**RE: *Comments on Proposed Permit No. WQ0015201001. Applicant JPHD, Inc., 17024 Hamilton Pool Road, Austin, Texas 78738.***

**RE: *Comments on Proposed Permit No. WQ0015201001. Applicant JPHD, Inc., 17024 Hamilton Pool Road, Austin, Texas 78738.***

**Legend**

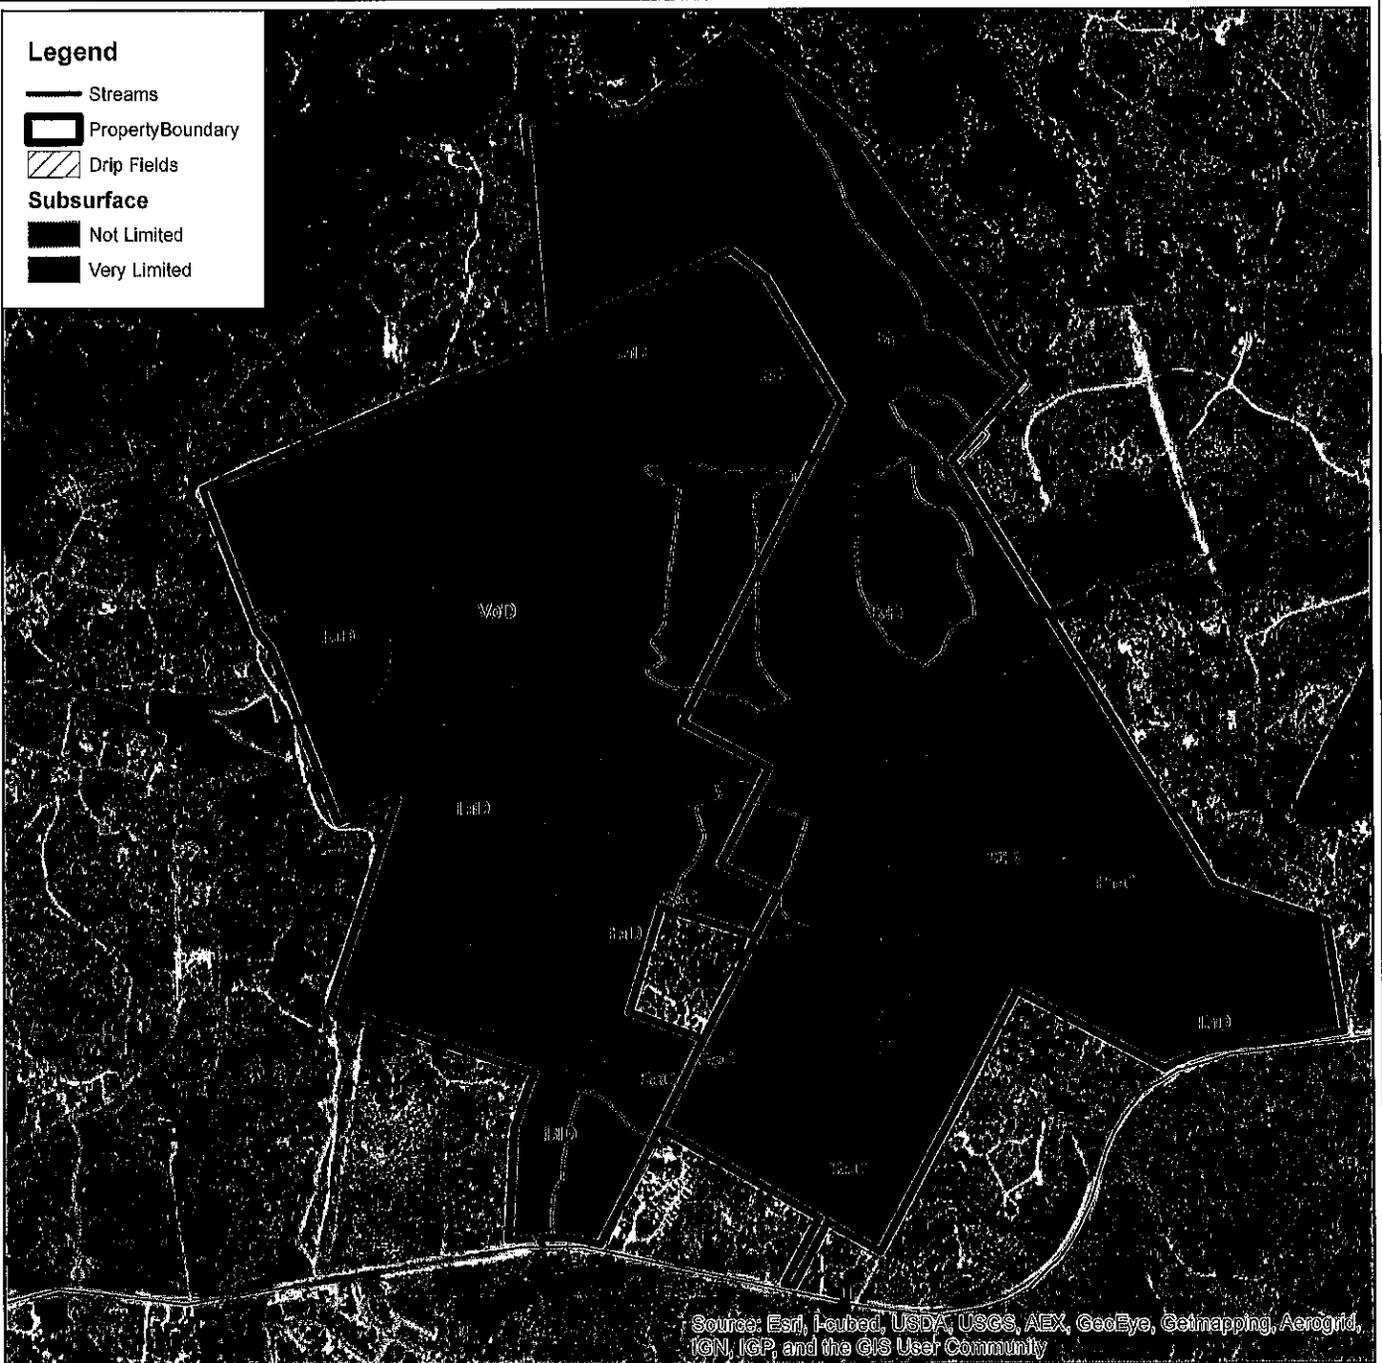
1. Soils within the proposed irrigation fields would not be adequate to absorb and dispose of applied effluent under the proposed permit without contributing to subsurface migration of effluent and waste loads associated with effluent into adjacent streams and groundwater. The attached figure is a map of the proposed irrigation fields overlying soils as classified by the Natural Resources Conservation Service. The map shows that almost all of the proposed irrigation areas would be located over either Tarrant (TaD) or Brackett-Rock (BiD) outcrop soils. These are some of the thinnest soils in the Texas Hill Country, with soil depths as little as zero to six inches. They are unsuited for effluent irrigation. This lack of suitability is confirmed by the Natural Resource Conservation Service most restrictive rating category for almost all soils on the site proposed for irrigation as "very limited" for subsurface drip irrigation due to depth to bedrock.

**Legend**

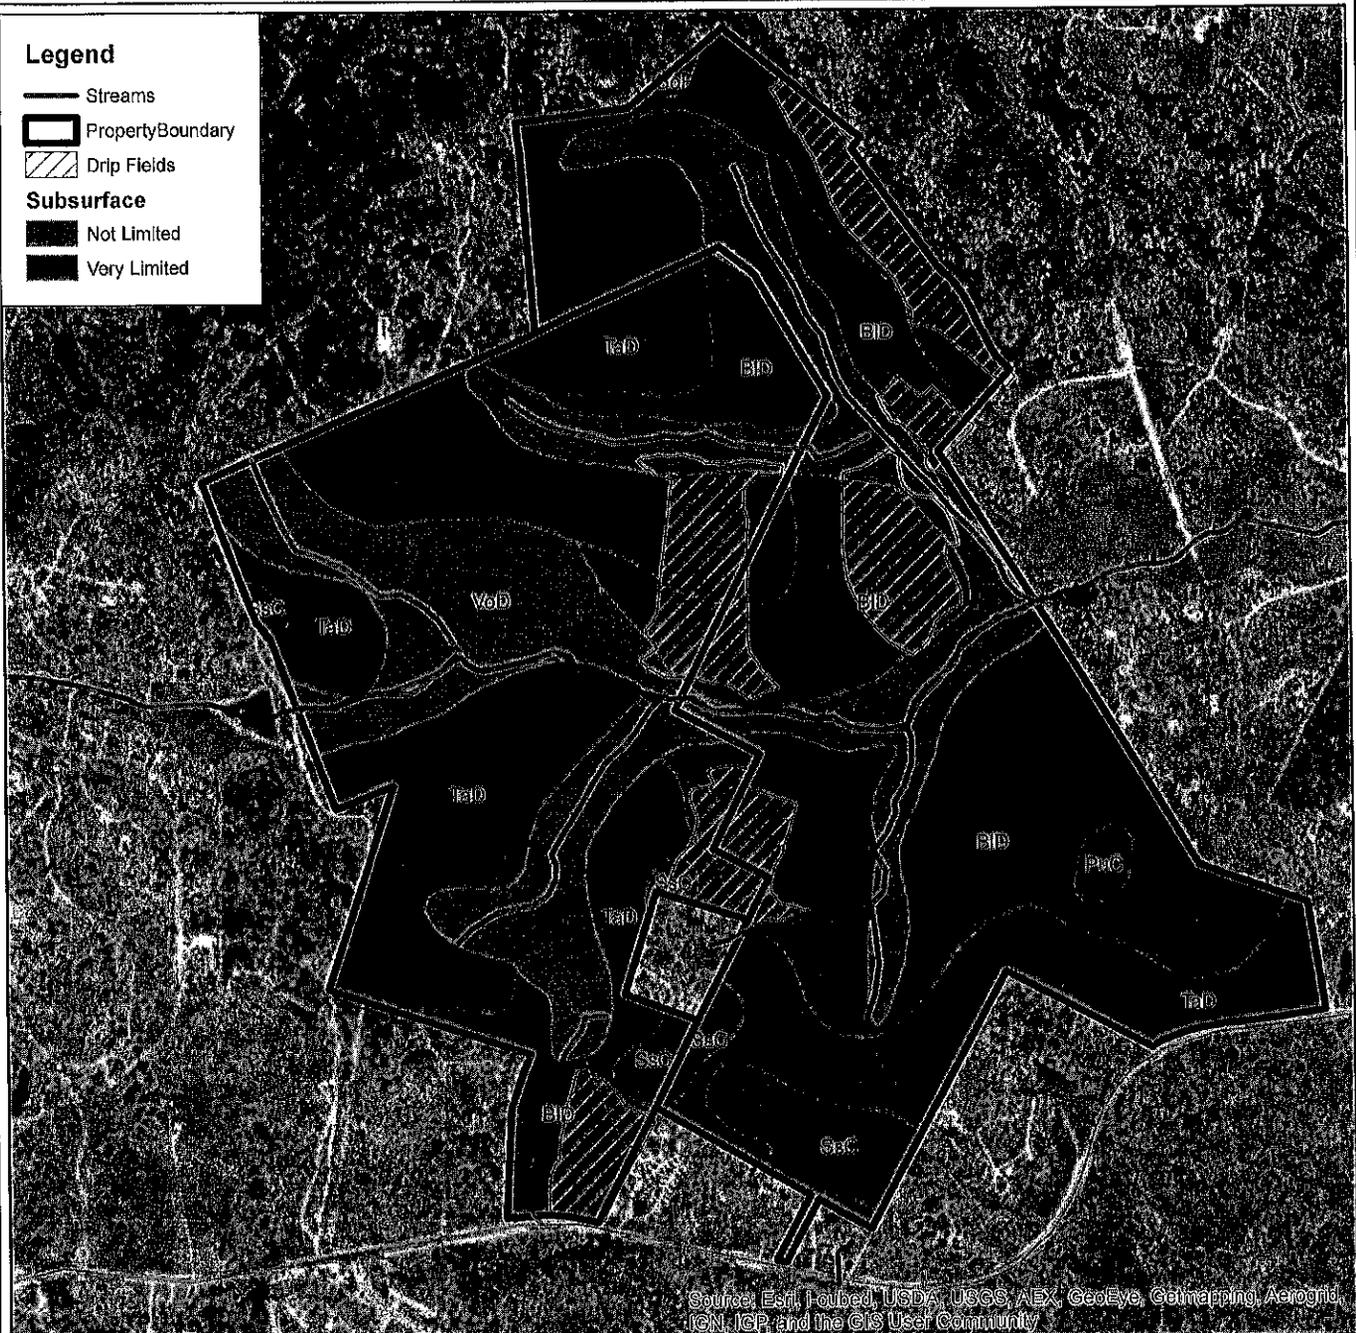
1. Soils within the proposed irrigation fields would not be adequate to absorb and dispose of applied effluent under the proposed permit without contributing to subsurface migration of effluent and waste loads associated with effluent into adjacent streams and groundwater. The attached figure is a map of the proposed irrigation fields overlying soils as classified by the Natural Resources Conservation Service. The map shows that almost all of the proposed irrigation areas would be located over either Tarrant (TaD) or Brackett-Rock (BiD) outcrop soils. These are some of the thinnest soils in the Texas Hill Country, with soil depths as little as zero to six inches. They are unsuited for effluent irrigation. This lack of suitability is confirmed by the Natural Resource Conservation Service most restrictive rating category for almost all soils on the site proposed for irrigation as "very limited" for subsurface drip irrigation due to depth to bedrock.
